# PLANNING CLEARANCE

GRAND JUNCTION PLANNING DEPARTMENT

Showroom Additional  
Steve McCallum 242-7171

AN ALCO BUILDING FOR  
GRAND MESA MARINE

**SITE PLAN**  
1" = 50'

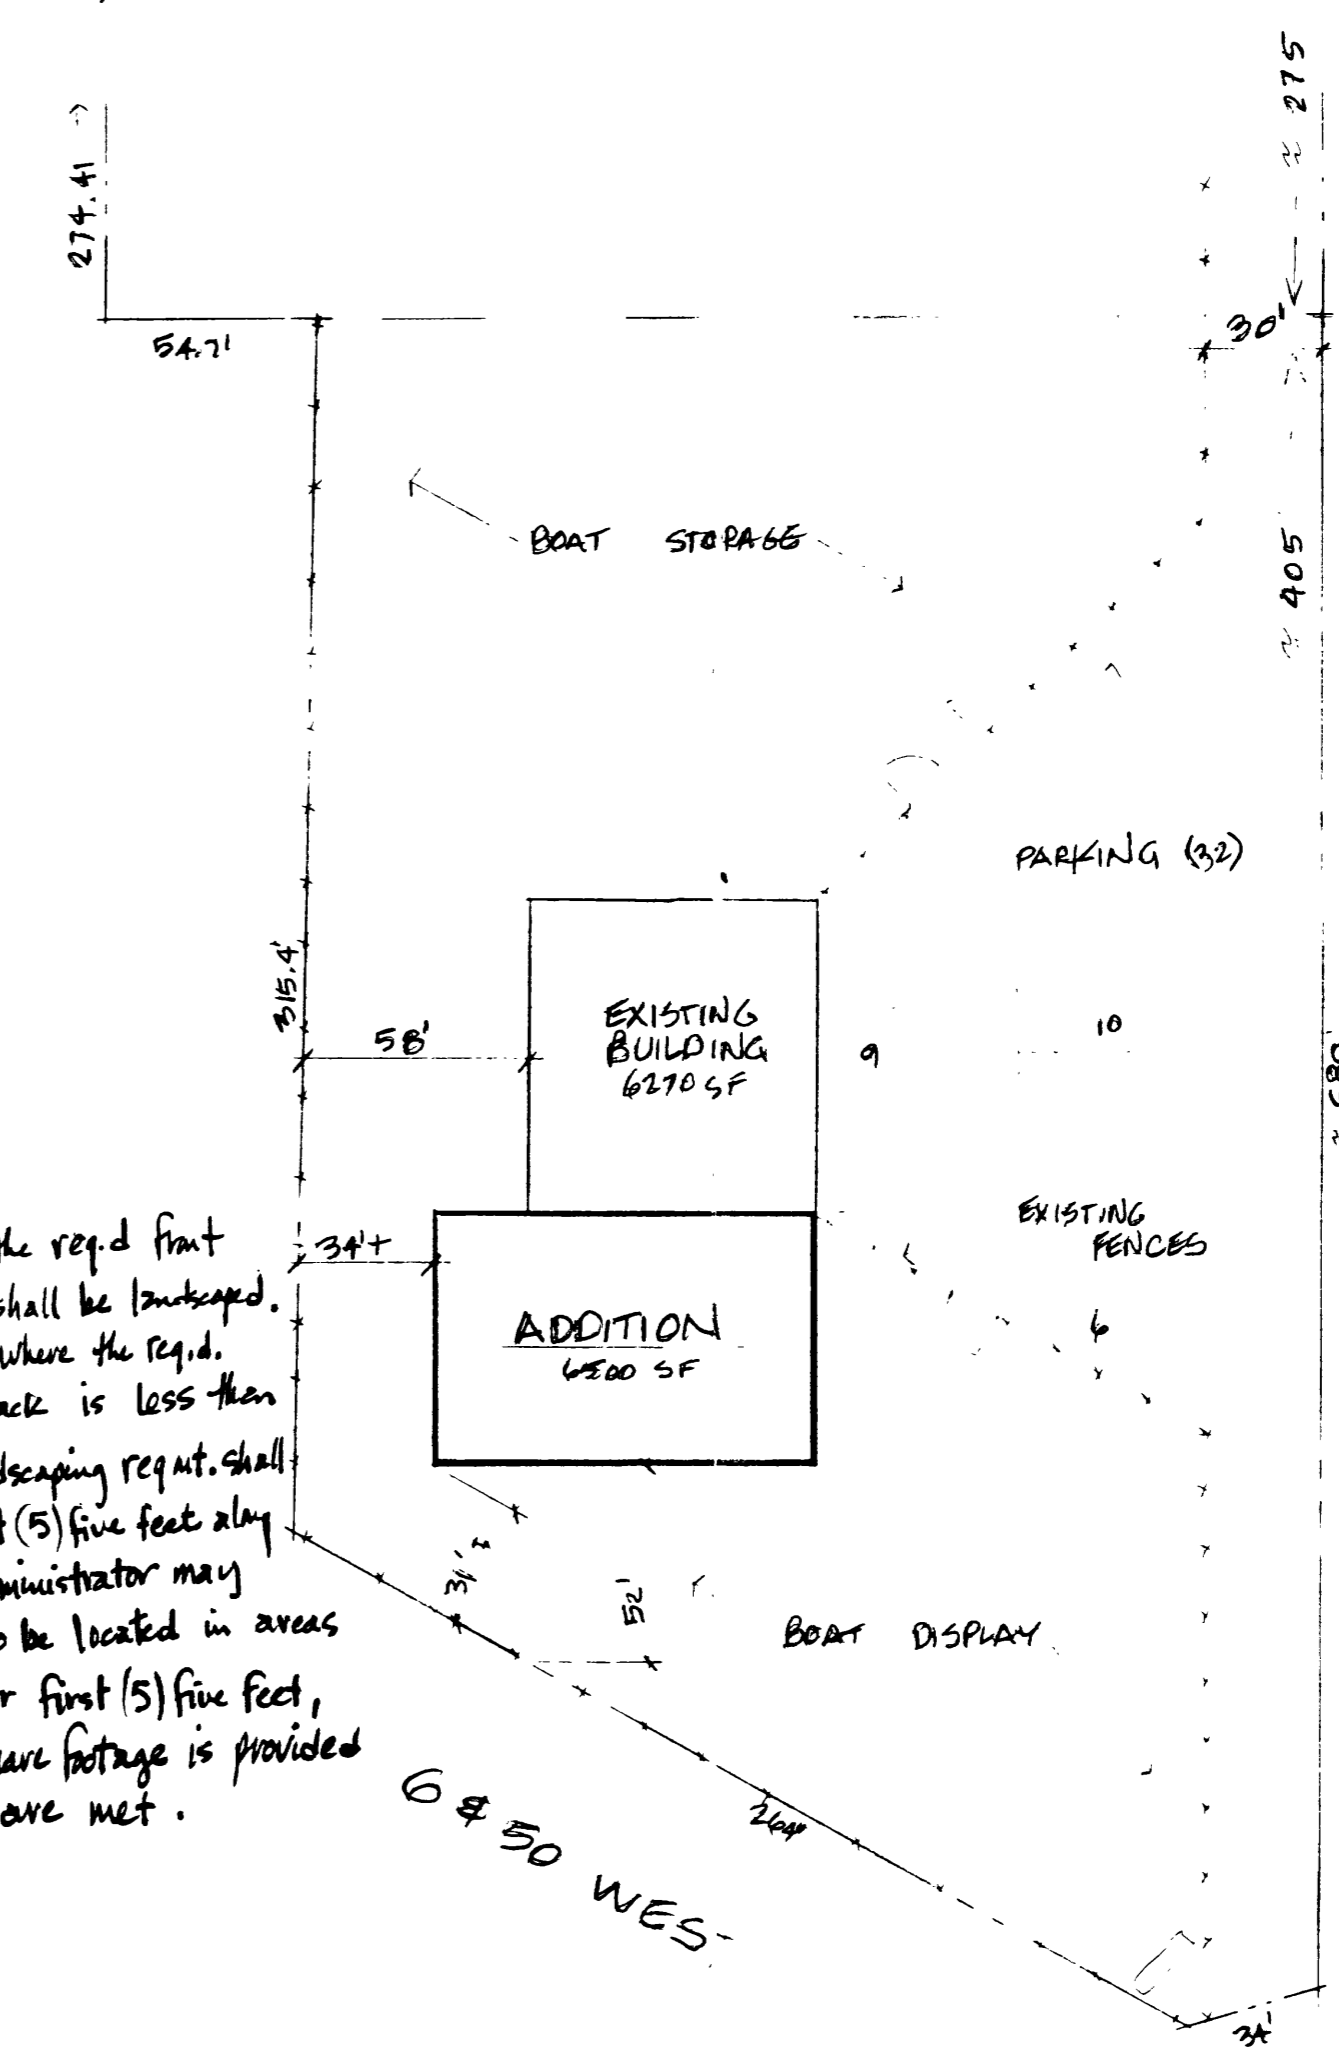
LANDSCAPING/SCREENING: See attached letter - per Sec. 4-2-12:D: 75% of lot 5 feet along street shall be landscaped

Per Sec. 4-2-12: D } A minimum  
of 75% of the req'd first  
yard setback shall be landscaped.  
On any street where the req'd.  
setback is less than  
five feet, the landscaping req't. shall  
be 75% of the first (5) five feet along  
that street. The administrator may  
approve the landscaping to be located in areas  
other than the setback, or first (5) five feet,  
as long as the total required square footage is provided  
and the intents of this Code are met.

25 ROAD  
680  
- 275 north prop  
405 south prop  
-----  
280  
1264  
669  
x 5  
3,345 x 75% = 2509 #  
-----  
680 If both (favor) parcels are included  
+ 269  
944  
x 5  
9720 # x 75% = 3,540 # of landscape needed
